Science Plan for Fall Steady Flows

USGS/SBSC/Grand Canyon Monitoring and Research
Center

Fig 3. Conceptual Diagram of Colorado River Ecosystem
 (Note: Many important components and linkages not included. Linkages that are addressed in this plan are in black while linkages that are not addressed in this plan are in grey)

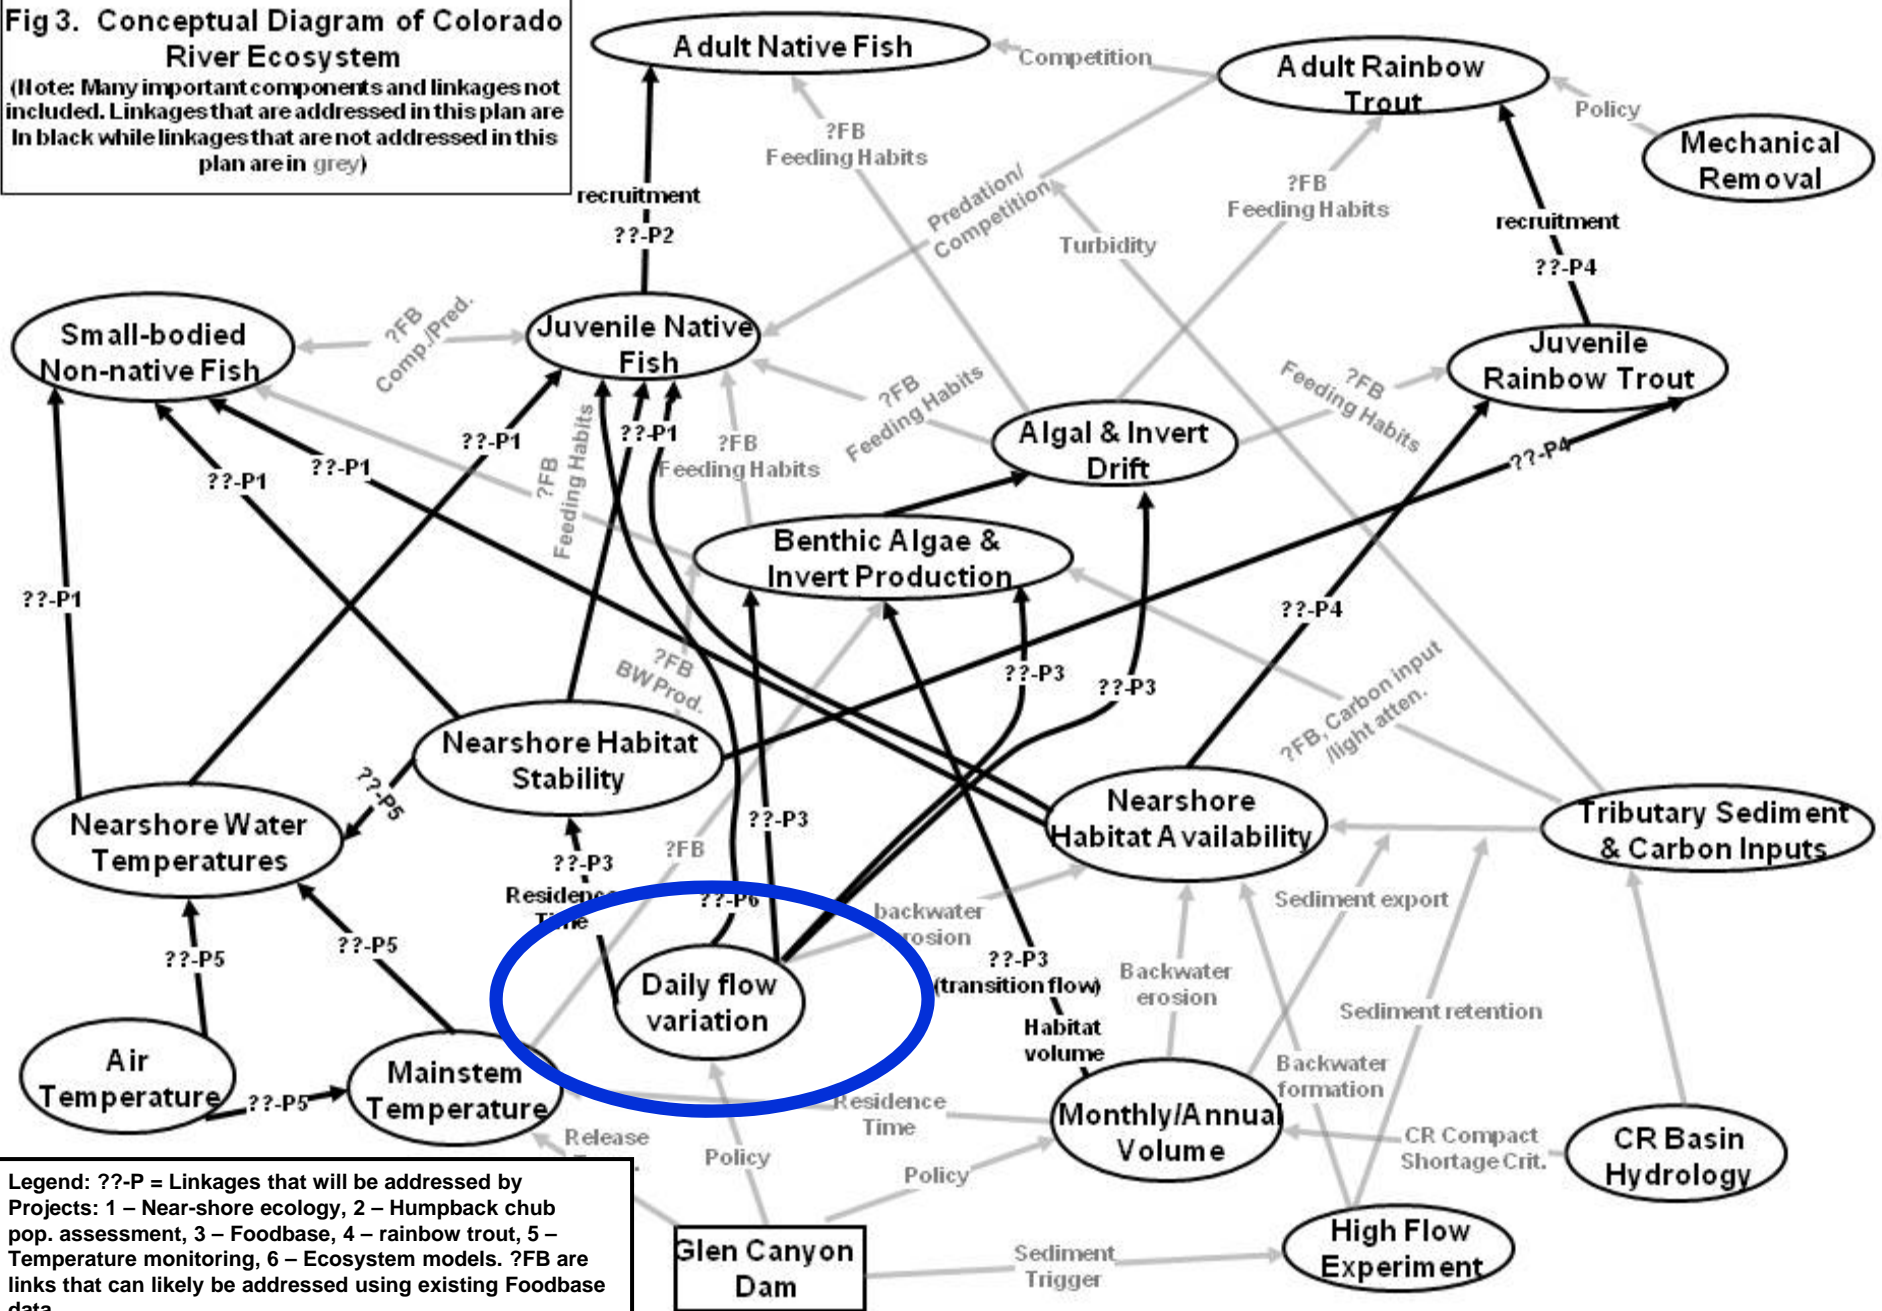
- **Better integration & Pursue modeling**
 - Added ecosystem modeling to study plan (R12.P1.10)
 - Added conceptual diagram showing integration
- **How will plan answer SSQs?**
 - Linked projects with SSQs
- **Include results of LSSF and 2005 Steady Flows**
 - Added
- **Using same flow level across years is flawed**
 - Changed recommendation to “lowest flows” (to maximize backwater habitat [Grams and others 2010])
 - 2008-2010 FSF discharges: 12 kcfs, 10 kcfs, 8 kcfs.
